SUBJECT: ISSUANCE OF TECHNICAL SPECIFICATION AMENDMENTS  
FOR THE BROWNS FERRY NUCLEAR PLANT UNITS 1, 2, AND 3  
(TAC NOS. M91944, M91945, AND M91946) (TS 349)

The Commission has issued the enclosed Amendment Nos. 224, 239, and 198 to Facility Operating License Nos. DPR-33, DPR-52, and DPR-68 for the Browns Ferry Nuclear Plant (BFN) Units 1, 2, and 3, respectively. These amendments are in response to your application dated March 31, 1995, and supplemented on July 14, 1995. The amendments revise the BFN Units 1, 2, and 3 reactor vessel pressure-temperature curves and bolt-up temperatures.

SAFETY EVALUATION BY THE OFFICE OF NUCLEAR REACTOR REGULATION  
RELATED TO AMENDMENT NO. 224 TO FACILITY OPERATING LICENSE NO. DPR-33  
AMENDMENT NO. 239 TO FACILITY OPERATING LICENSE NO. DPR-52  
AMENDMENT NO. 198 TO FACILITY OPERATING LICENSE NO. DPR-68

BROWNS FERRY NUCLEAR PLANT, UNITS 1, 2, AND 3

Figure 3.6.-1

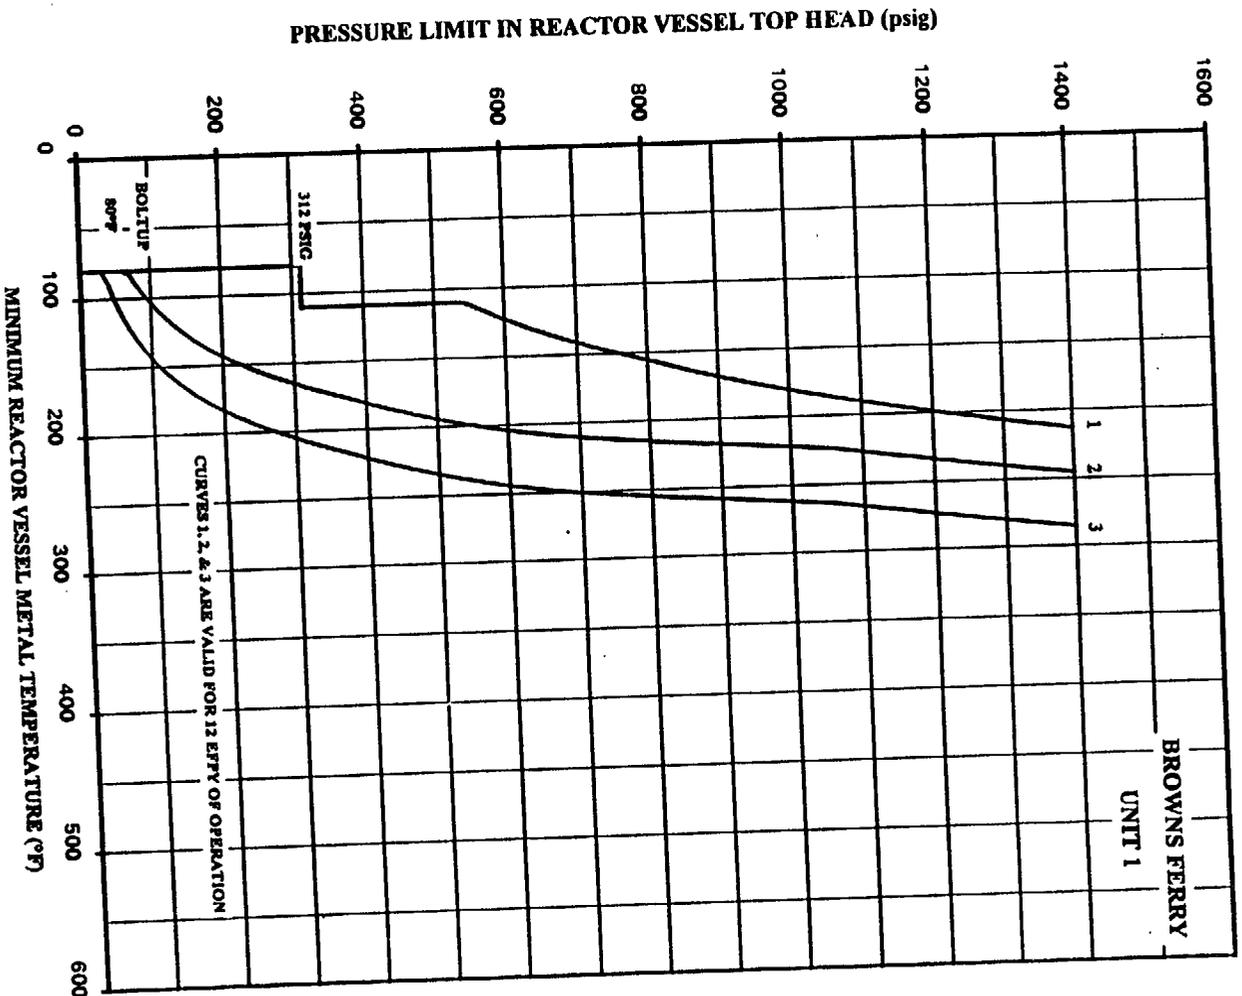
**Curve No. 1**

Minimum temperature for pressure tests such as required by Section XI.

Minimum temperature of 191° F is required for test pressure of 1,100 psig.

**Curve No. 2**

Minimum temperature for mechanical heatup or cooldown following nuclear shutdown.

**Curve No. 3**

Minimum temperature for core operation (criticality) includes additional margin required for 10CFR150, Appendix G, Par. IV.A.3 which became effective July 26, 1983.

**Notes**

These curves include sufficient margin to provide protection against feedwater nozzles degradation. The curves allow for shifts in RT NDT of the Reactor vessel bellhine materials, in accordance with Reg. Guide 1.99 Rev. 2, to compensate for radiation embrittlement for 12 EFPY.

Substituting the ARTs of BFN Units 1, 2, and 3 limiting materials into equations in SRP 5.3.2, the staff verified that the proposed P/T limits for heatup, cooldown, criticality, and inservice hydrostatic test satisfy the requirements in paragraphs IV.A.2 and IV.A.3 of Appendix G of 10 CFR Part 50.

The staff has performed an independent analysis to verify the licensee's proposed BFN Units 1, 2, and 3 P/T limits. The staff concludes that the proposed P/T limits for heatup, cooldown, inservice hydrostatic test and criticality are valid for 12 effective full power years, because: (1) the limits conform to the requirements of Appendix G of 10 CFR Part 50 and GL 88-11, and (2) the material properties and chemistry used in calculating the P/T limits are consistent with or conservative compared to data submitted under GL 92-01; hence, the proposed BFN Units 1, 2, and 3 P/T limits may be incorporated in the TS. In addition, the proposed changes in the Bases section of the TS are consistent with the P/T limits changes and; therefore, are acceptable.

Figure 3.6.-1

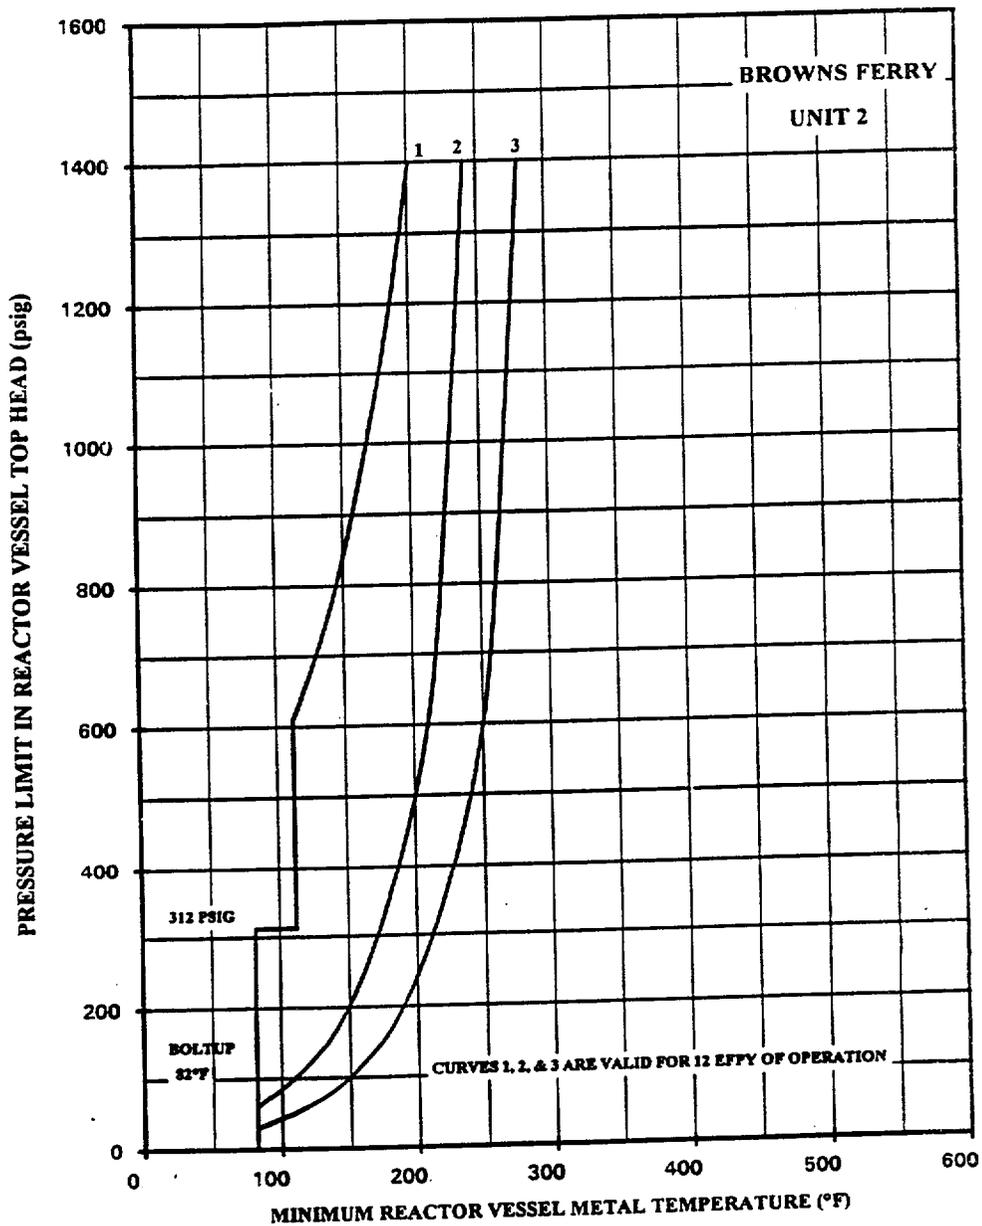
**Curve No. 1**  
Minimum temperature for pressure tests such as required by Section XI. Minimum temperature of 178° F is required for test pressure of 1,100 psig.

**Curve No. 2**  
Minimum temperature for mechanical heatup or cooldown following nuclear shutdown.

**Curve No. 3**  
Minimum temperature for core operation (criticality) includes additional margin required for 10CFR50, Appendix G, Par. IV.A.3 which became effective July 26, 1983.

**Notes**  
These curves include sufficient margin to provide protection against feedwater nozzle degradation. The curves allow for shifts in  $RT_{NDT}$  of the Reactor vessel beltline materials, in accordance with Reg. Guide 1.99 Rev. 2, to compensate for radiation embrittlement for 12 EFPY.

Figure 3.6.-1

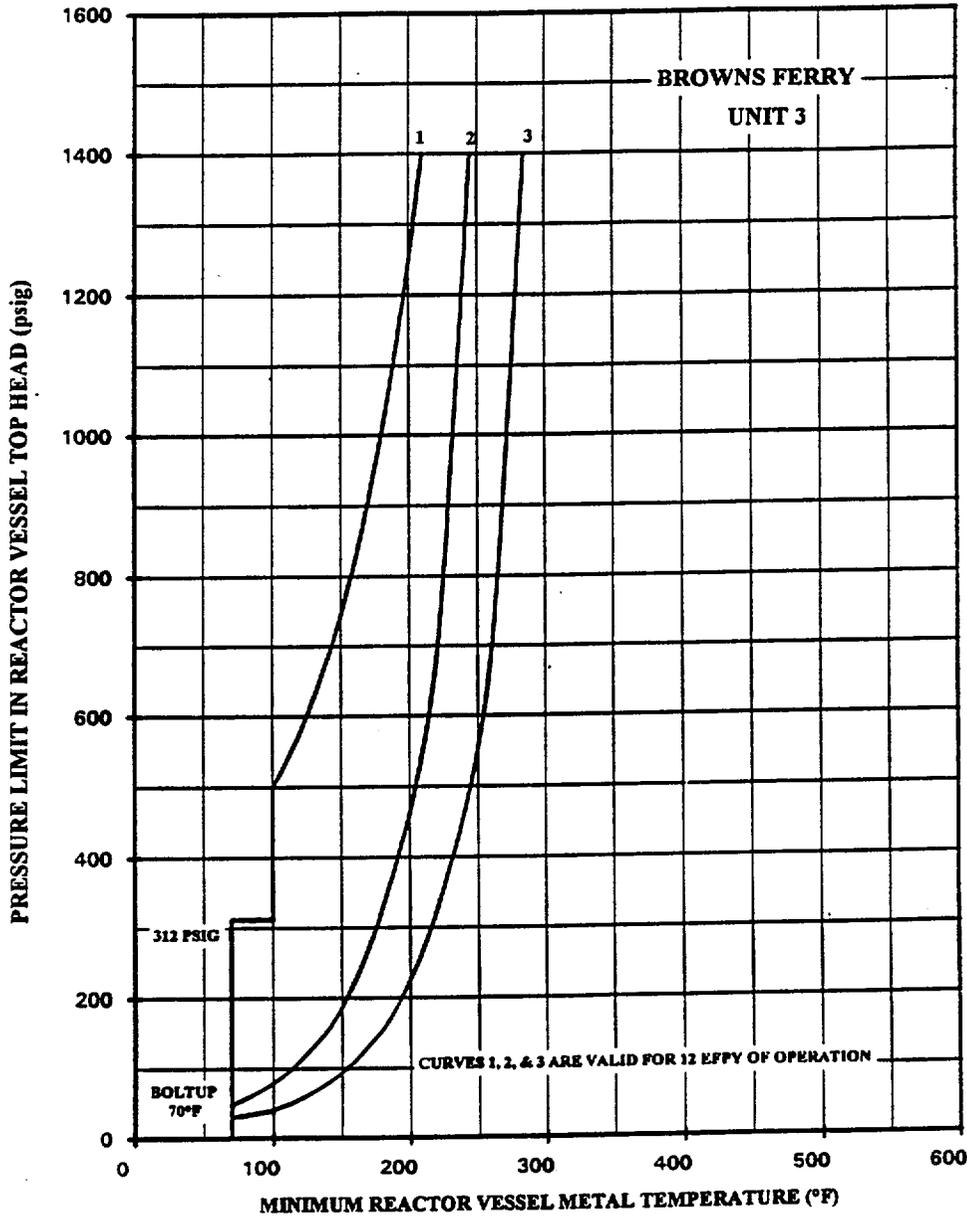
**Curve No. 1**  
Minimum temperature for pressure tests such as required by Section XI. Minimum temperature of 189° F is required for test pressure of 1,100 psig.

**Curve No. 2**  
Minimum temperature for mechanical heatup or cooldown following nuclear shutdown.

**Curve No. 3**  
Minimum temperature for core operation (criticality) includes additional margin required for 10CFR50, Appendix G, Par. IV.A.3 which became effective July 26, 1983.

**Notes**  
These curves include sufficient margin to provide protection against feedwater nozzle degradation. The curves allow for shifts in  $RT_{NDT}$  of the Reactor vessel beltline materials, in accordance with Reg. Guide 1.99 Rev. 2, to compensate for radiation embrittlement for 12 EFY.
